Our Case Number: ABP-317767-23

Re: Proposed construction of 39 residential units, widening of Pausdeen Bridge and all associated site works.  
Newtown/Ardclough Road, Newtown, Celbridge, Co. Kildare.

## Planning Observation Submissions to An Bord Pleanála

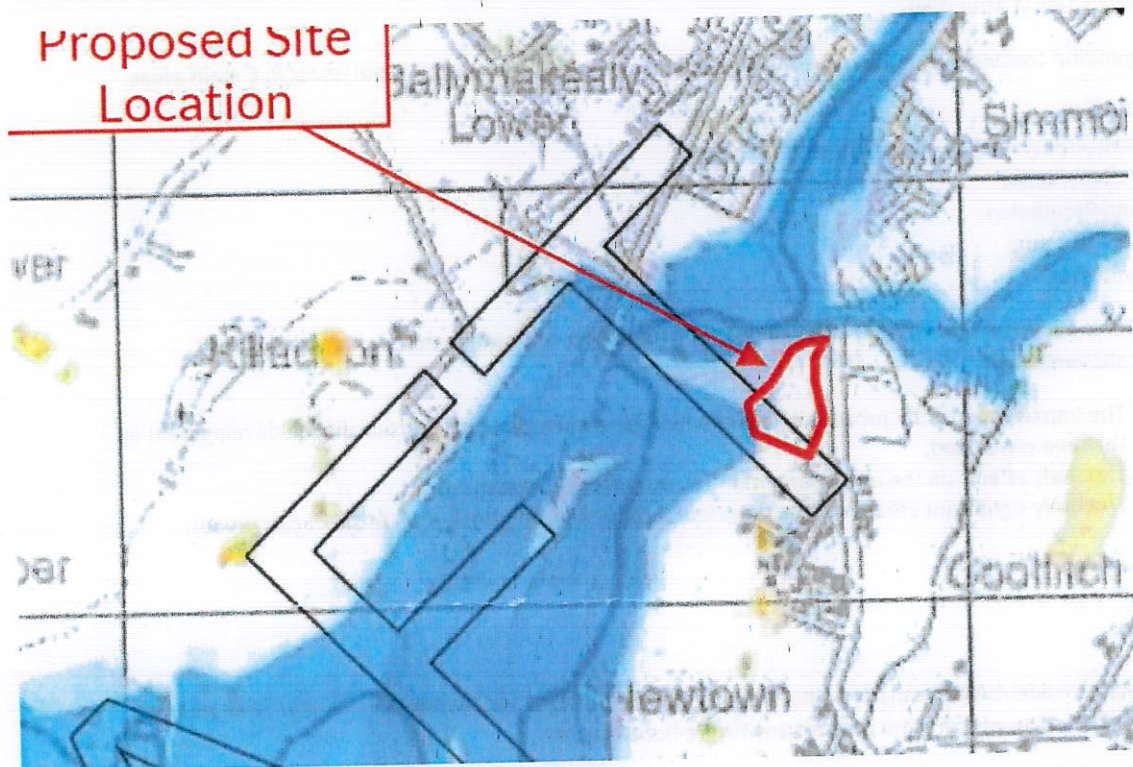
Outdated Maps: Chelmsford Manor does not appear on any of Tobins utilised maps

Very little tolerance: The predicted high water level of the site at O9LIFF02820 and 0.1% AEP is 52.95m. However evidence shows water further into the site. The Topographical survey indicates a Northwest fall

with levels varying from 53.80 to 53.0m OD at the Northwestern Edge. Are we to assume therefore that it was the illegal dumping which has helped to raise the site? Also 5cm clearance from a map without empirical current site data is hardly reassuring as good tolerance to flooding.
